STAFF REPORT
COMMUNITY DEVELOPMENT DEPARTMENT

HEARING DATE: November 9, 2022

SUBJECT: FP-2022-0032
Apex Northwest No. 3 – FP

B. Final Plat (dated: 9/7/2022)

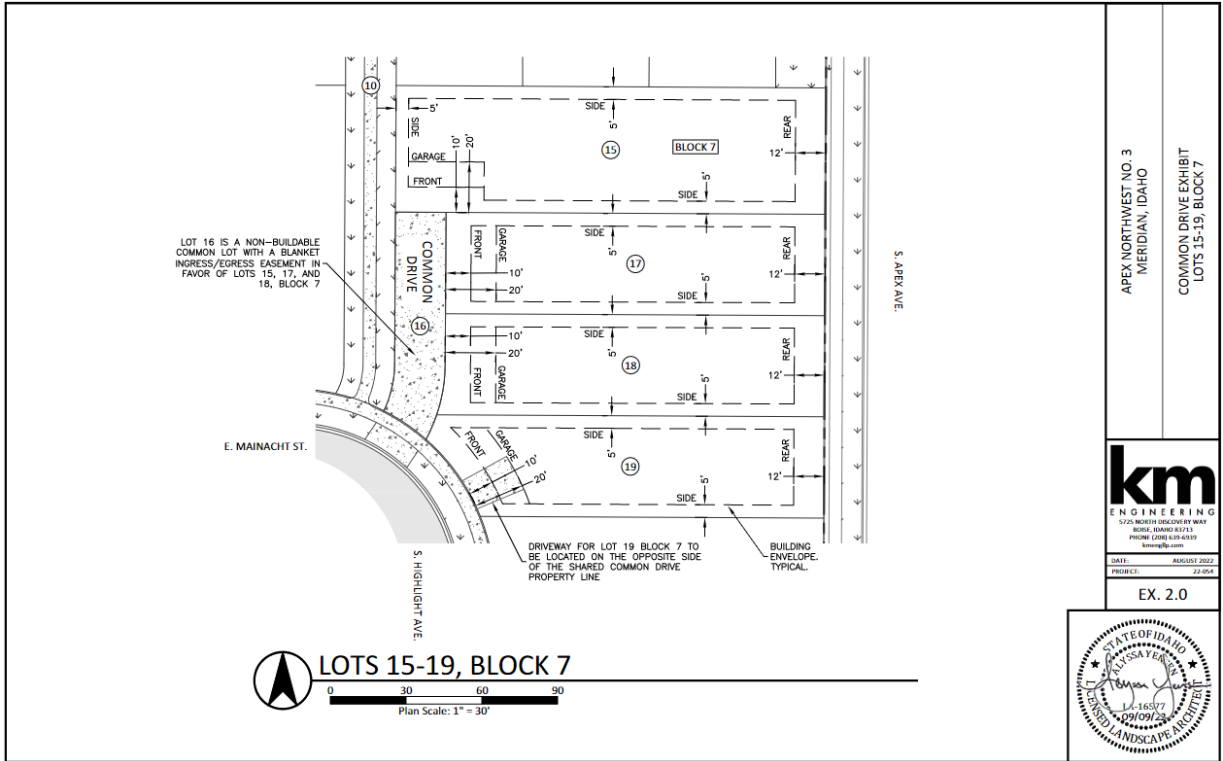
3. Prior to submittal for the City Engineer's signature, have the Certificate of Owners and the accompanying acknowledgement signed and notarized.
4. The final plat prepared by KM Engineering stamped by Aaron L. Ballard, dated: 9/9/2022, included in Section V.B shall be revised as follows:

- a. Include the recorded instrument number of the City of Meridian easement graphically depicted and noted on Sheet 2 and 3.
 - b. Note #9: Include the recorded instrument number of the ACHD public right-of-way easement (sidewalk).

- c. Note #10: Include the recorded instrument number of the City of Meridian easement.
 - d. Note #18: Include the recorded instrument number of the City of Meridian easement.

- e. Depict an easement or a common lot for the portion of the 20-foot wide street buffer on the west side of Apex Avenue along the rear of Lots 15-25, Block 7 per the conditions listed in the preliminary plat (H-2021-0087).

C. Common Driveway Exhibit

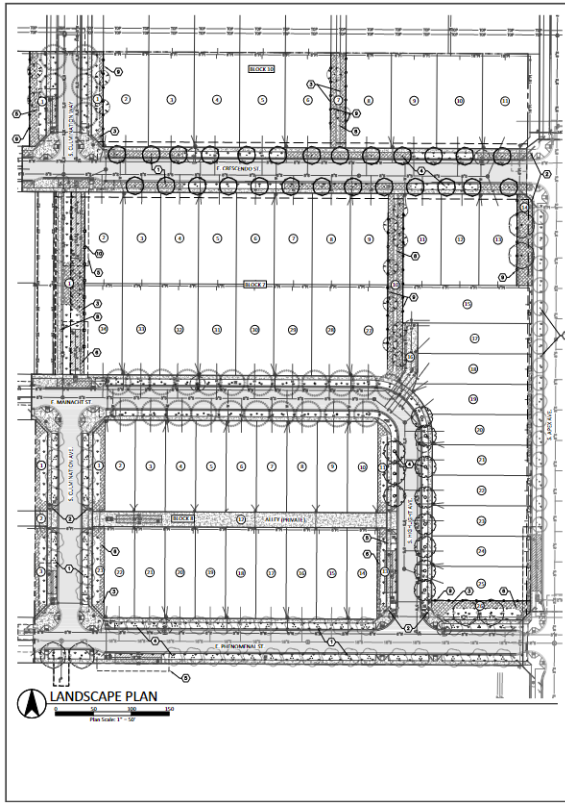
10. All fencing shall comply with the standards of UDC 11-3A-7C.
11. Revise the common driveway (Lot 16, Block 7) on Exhibit C. Extend the common drive on Lot 15, Block 7 and depict identical building setback envelope show on the adjacent lots to prevent homeowners from backing down the common driveway in accord with UDC 11-6C-3D.

D. Landscape Plan (dated: 9/9/22)

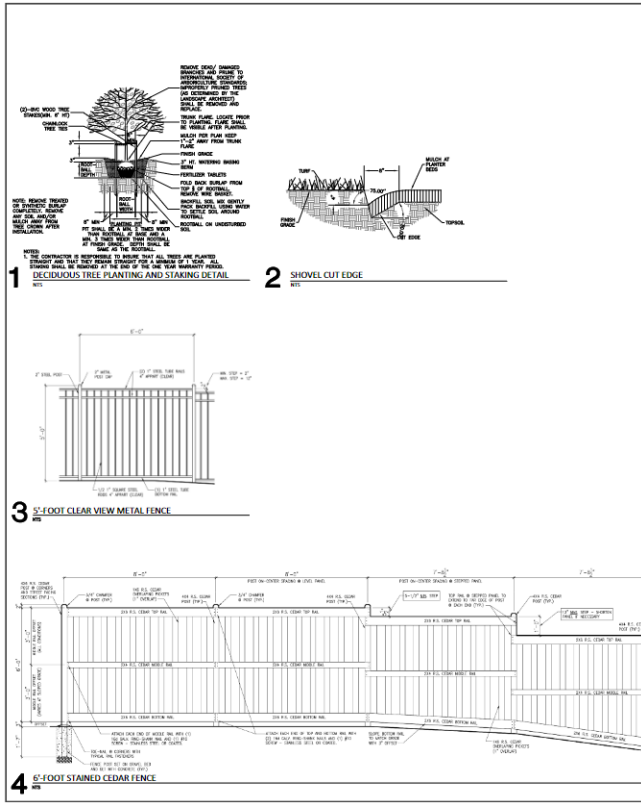
5. The landscape plan prepared by KM Engineering, dated 9/9/22, included in Section V.C, shall be revised as follows:
 - a. Include calculations in the Project Calculations table that demonstrate compliance with the standards for pathway ([11-3B-12C](#)) landscaping; include required vs. provided number of trees. Landscaping is required along *all* pathways.

- b. Depict a portion of the 20-foot wide street buffer or common lot on the west side of Apex Avenue along the rear of Lots 15-25, Block 7 with landscaping in accord with the standards listed in UDC [11-3B-7C](#) per the conditions listed in the preliminary plat (H-2021-0087).
